RE: TxDOT's Oak Hill Parkway Project Response to Bruce Melton January 25, 2019 letter

Growth-Traffic Workshop Meeting Documentation Form

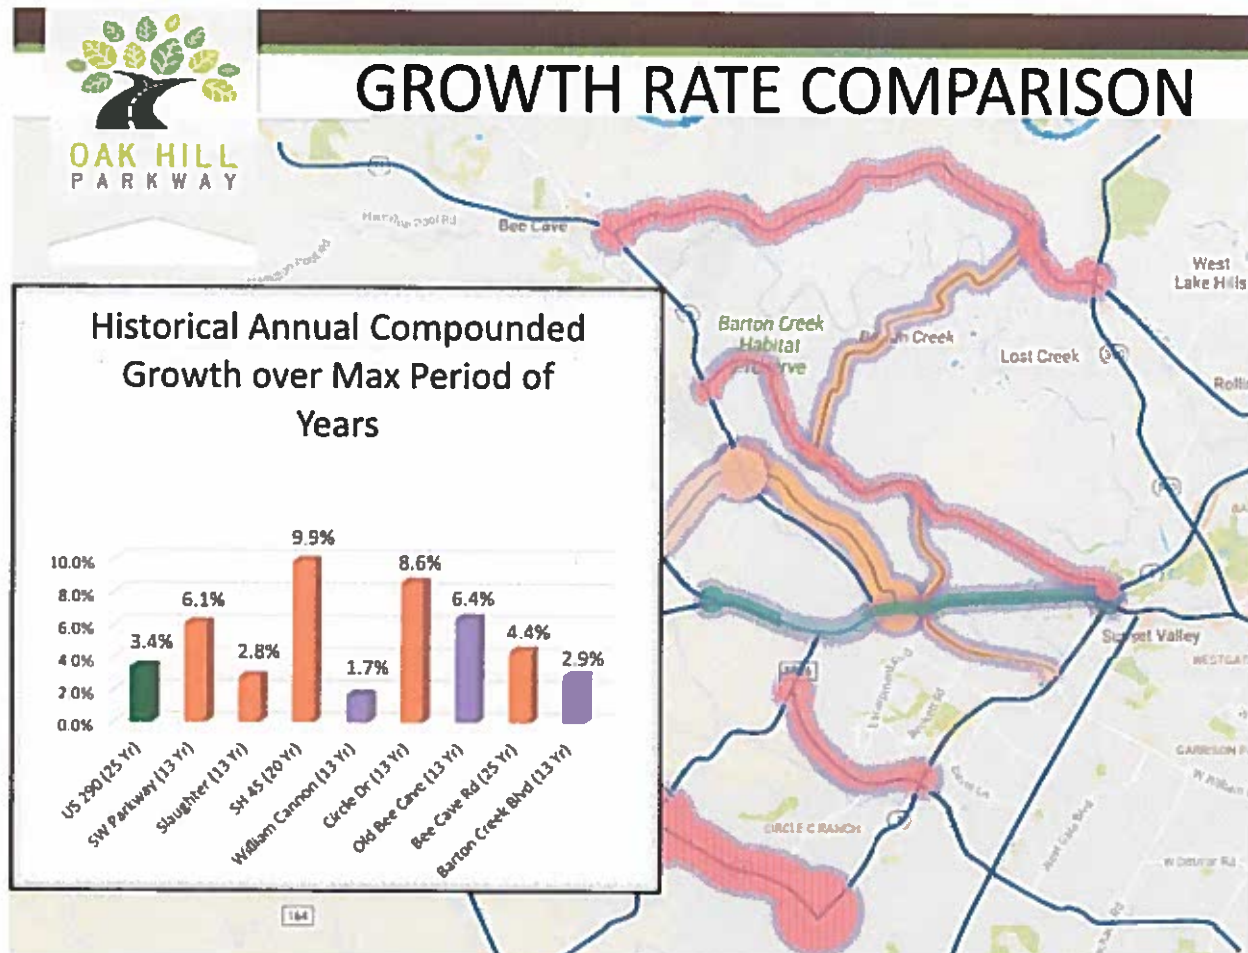
As shown on Page 2, the traffic projection rate proposed for US 290 (3.58% per year) is in line with the actual traffic growth rates experienced on some of the alternate routes like Southwest Parkway (6.2%), Circle Drive (8.6%) and Bee Cave Road (4.4%). These existing growth rates are considered relatively high.
